## #2019-91 Discount Tire – Preliminary PUD Project Review for Planning and Zoning Commission

<b><u>Meeting Date:</u></b>	July 3, 2019
<b><u>Request:</u></b>	Preliminary Planned Unit Development for a new 8,192 square-foot retail building.
<b><u>Location:</u></b>	5501 Northwest Highway
<b><u>Acreage:</u></b>	Approximately 2.1 acres
<b><u>Existing Zoning:</u></b>	B-2 PUD General Commercial Planned Unit Development
<b><u>Surrounding Properties:</u></b>	North: B-2 PUD General Commercial South: M Manufacturing (Three Oaks Recreation Area) East: B-2 PUD General Commercial West: M-L Manufacturing Limited
<b><u>Staff Contact:</u></b>	Elizabeth Maxwell (815.356.3615)

**DISCOUNT TIRE - ILC 11882  
CRYSTAL LAKE, ILLINOIS  
DIMENSIONED SITE PLAN**

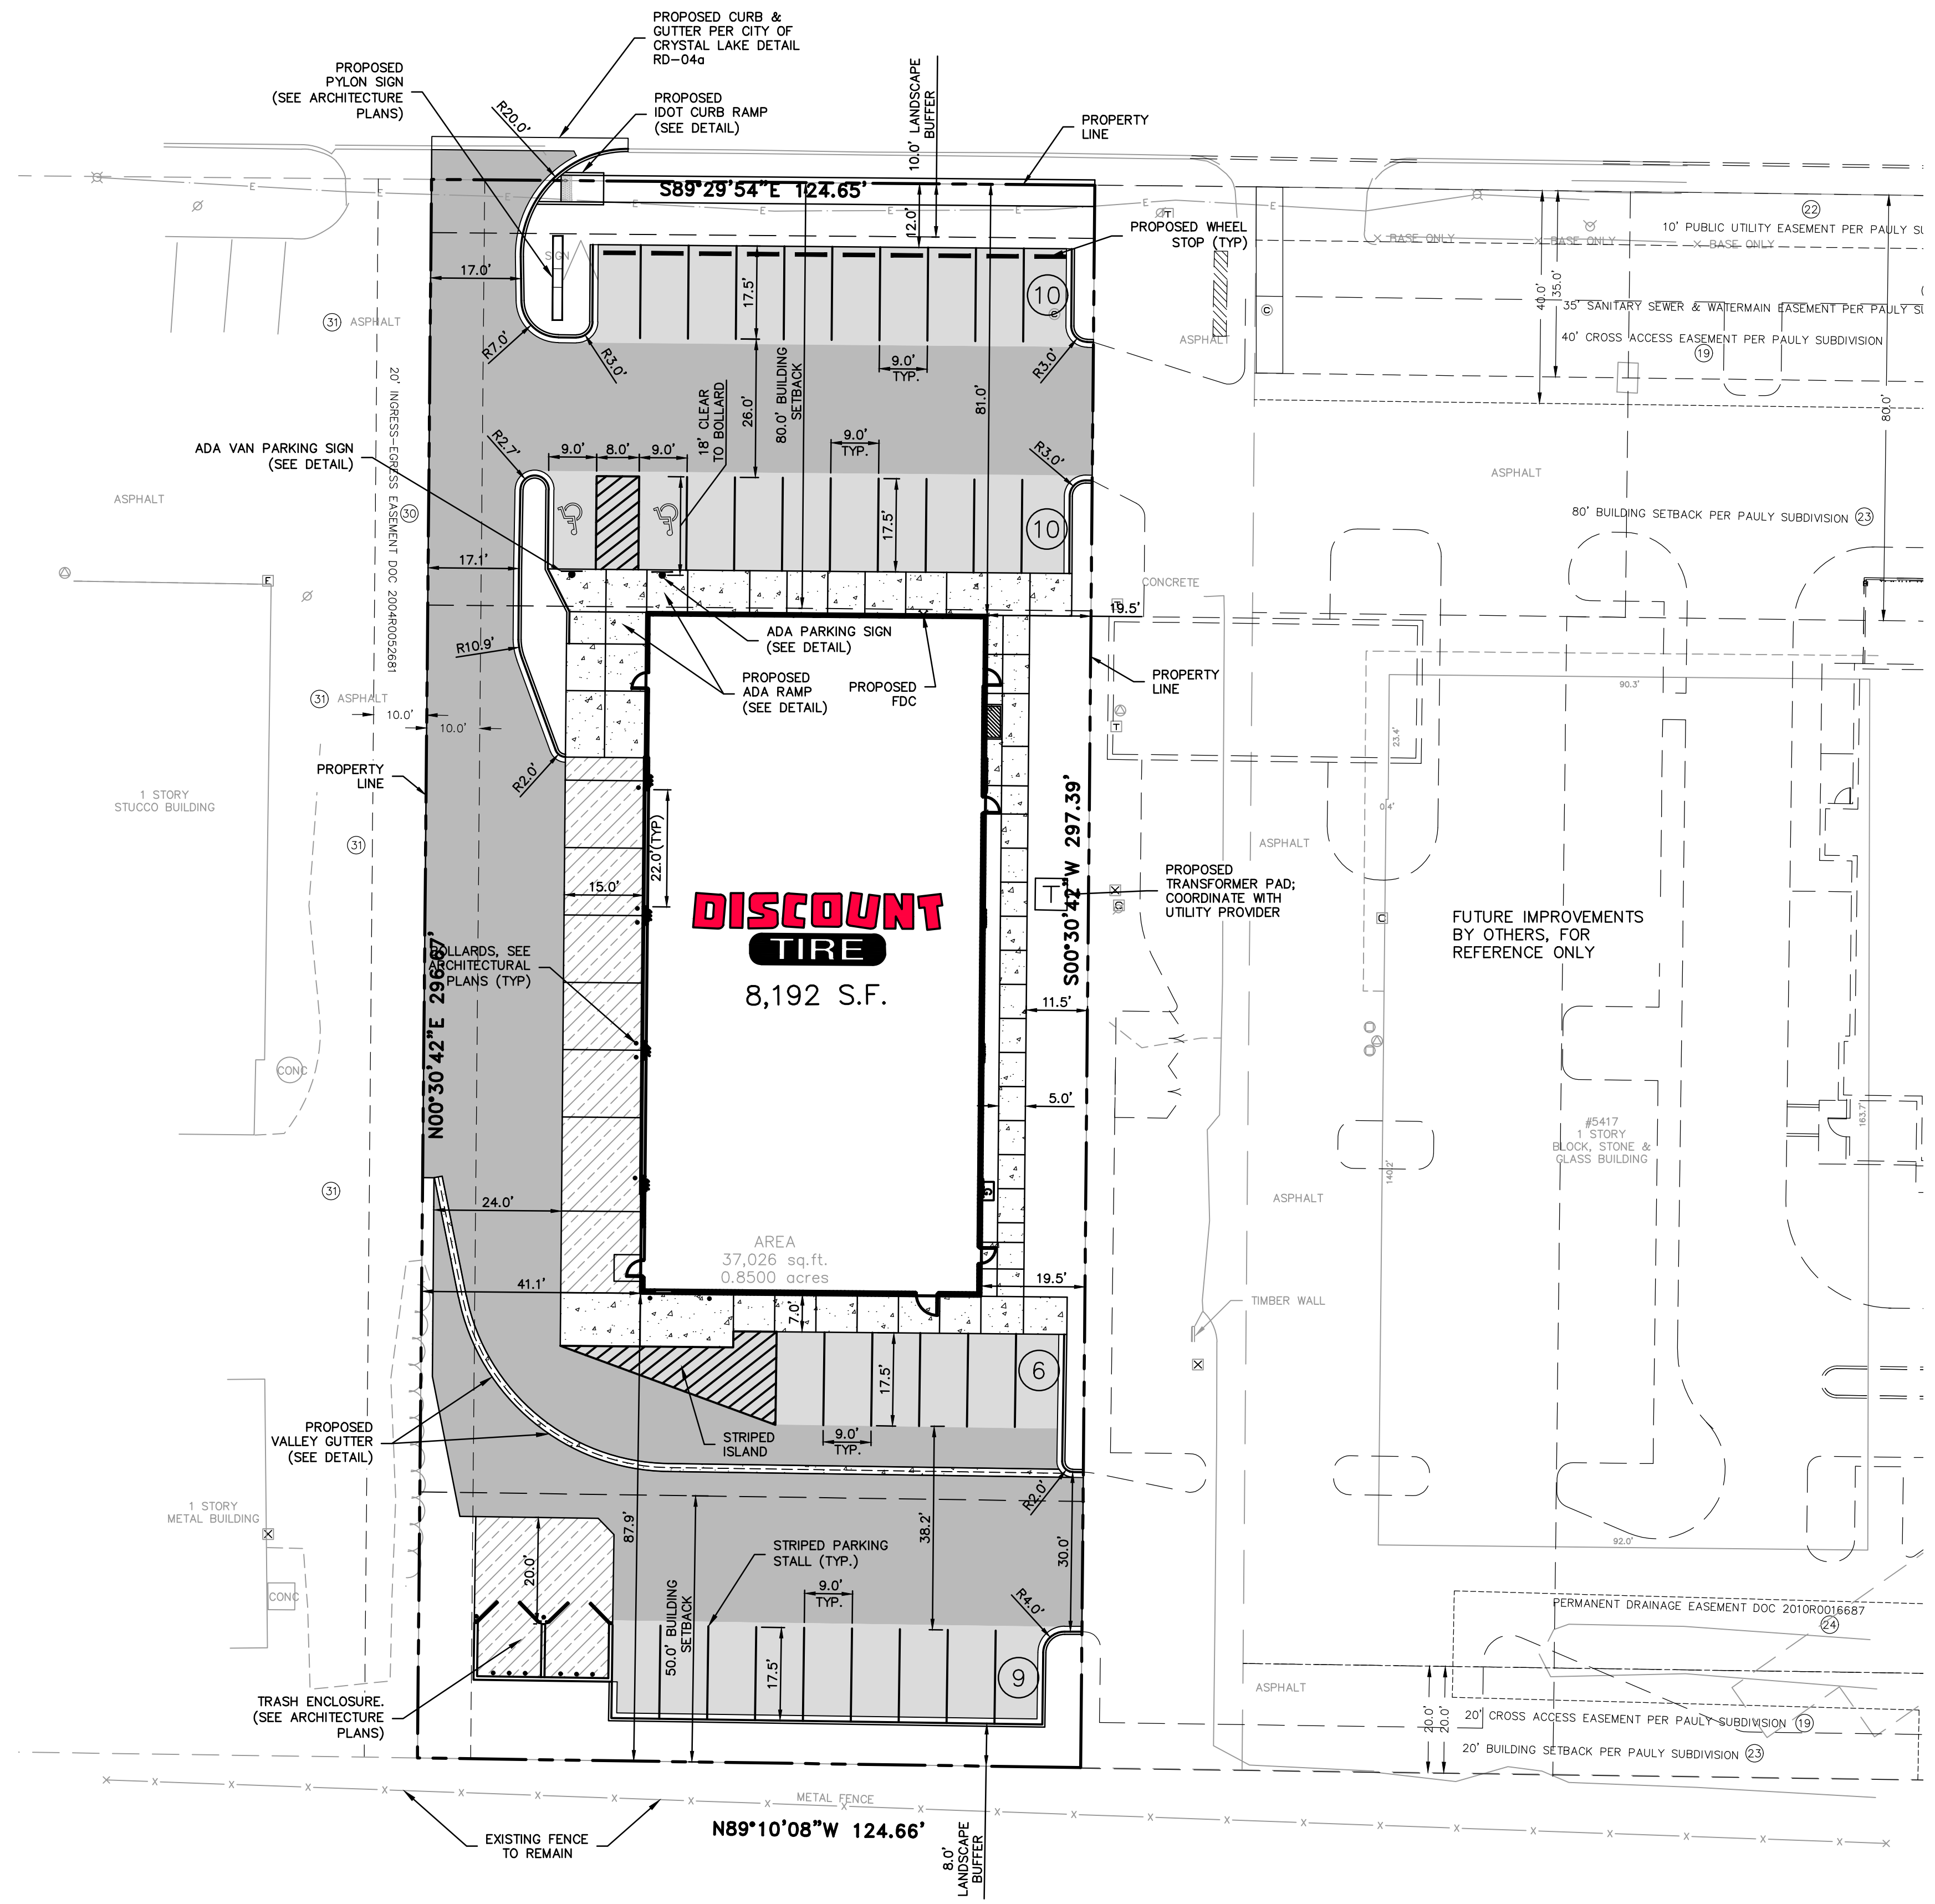
- The main access into the site is via a shared driveway with the adjacent business. A recorded shared access easement exists over the driveway.
- Parking is provided both in front and behind the building. The main customer parking would be in front of the building along Northwest Highway.
- The building is setback 81 feet from Northwest Highway and 87.9 feet from the south property line. There is a 50-foot building setback from the south property line established by the slope stabilization study.
- Sidewalk is provided on three sides of the building. **Additional sidewalk connections to the future boardwalk and the adjacent businesses are recommended.**

- Parking for the Automotive Repair, Minor use is based on 3 spaces per service bay and the total number of employees on site.
- The lot is providing a total of 35 spaces, 41 spaces are required.
- Staff recommends the property owner establish a shared parking agreement in addition to the shared access agreement with all four lots so a variation is not necessary.

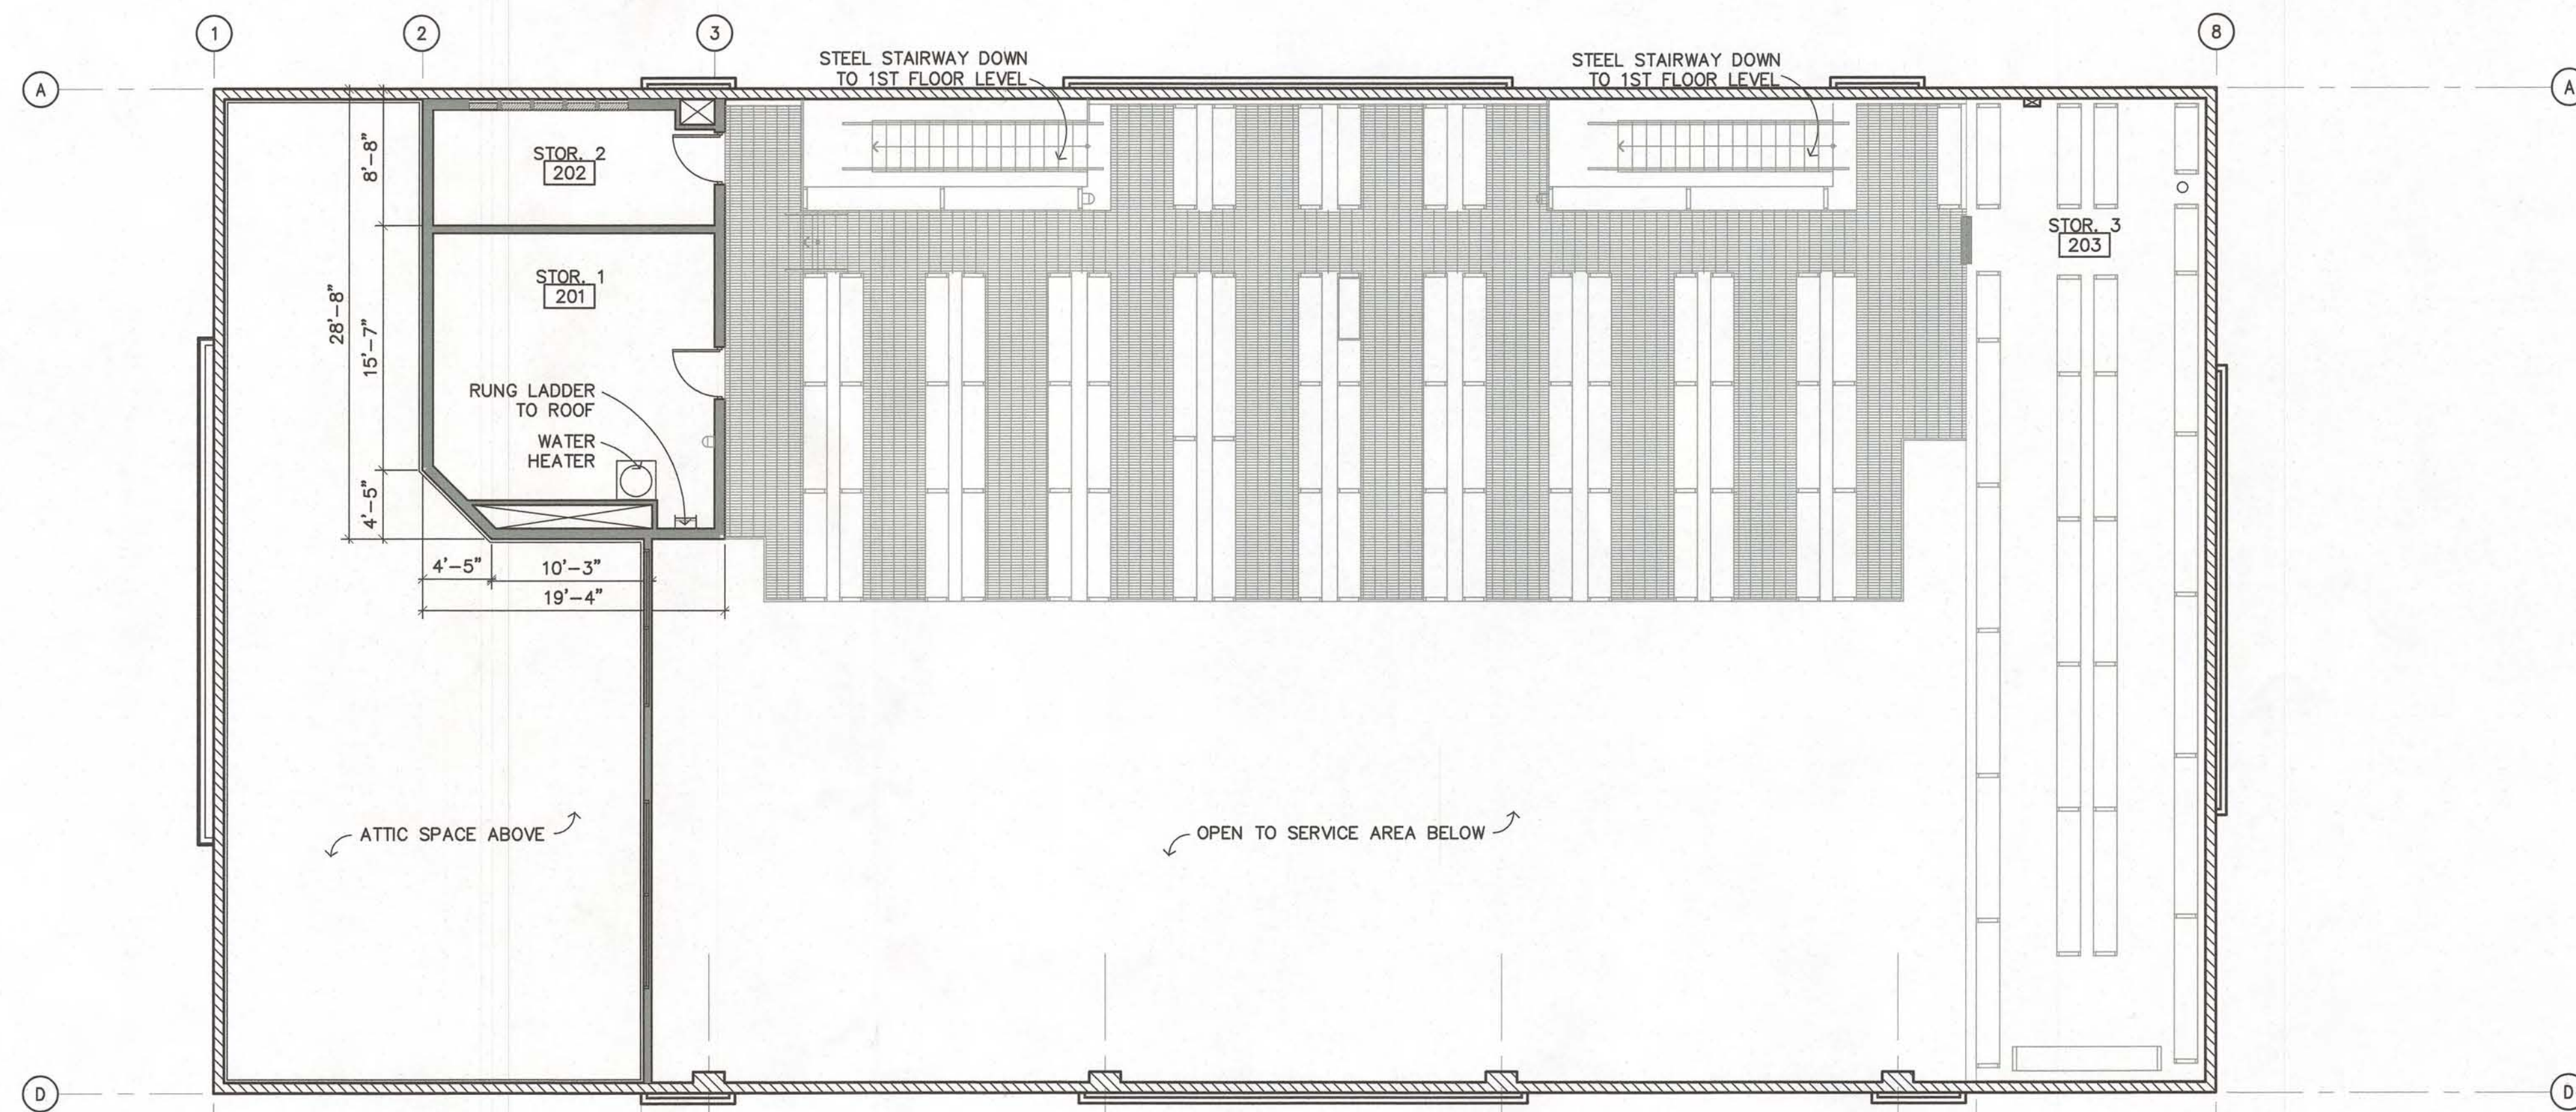
- The landscape plan illustrates 10 feet of parking lot screening, 20 feet is required. Due to the overhead utility lines only shrubs and flowers are planted here. A variation for 3 trees is requested. **Staff suggests adding small ornamental species like Serviceberry,**

**Crabapple or Japanese Maple.**

- Additional landscape area has been added on the east side of the building to meet the intent of the foundation base landscape requirements. **Staff suggests adding some foundation base landscape along the front of the building.**
- Landscape islands are illustrated, many of which would be shared with the adjacent lot. Landscape islands are required to contain 1 tree and 5 shrubs.
- Additional landscape is provided along the south property line. This landscape area may need to be removed to accommodate a future boardwalk.

- 3) Article 4-400 Landscape and Screening.
  - a) Section 4-400 E 3 from the requirement to plant parkway trees along Route 14 frontage. This is a variation of 3 trees. Staff suggests planting ornamental trees along this area.
  - b) Section 4-400 F1 from the requirement to provide an 8 x 15 landscape island at the end of every parking row. This variation is for the landscape island at the northwest corner of the building and the two missing islands at the back of the building, one at the southwest corner and one adjacent to the dumpster enclosure.

3. Landscape Plan
  - A. Add foundation base landscape along the front of the building, either at grade or in planter boxes to soften the front appearance of the building.

- B. The Fire Department Connection and hydrant must be relocated to the rear corner of the building. The landscape plan shall be revised to accommodate these changes.

- C. Add three ornamental trees to the front landscape screening area along Route 14.
  - D. Add taller shrubs to screen the transformer.
  - E. Landscape around the free-standing sign is required at 1 square-foot per 1 square-foot of signage, which includes a mix of at least 50% small deciduous trees, medium evergreen trees, ornamental trees, and deciduous and evergreen shrubs.
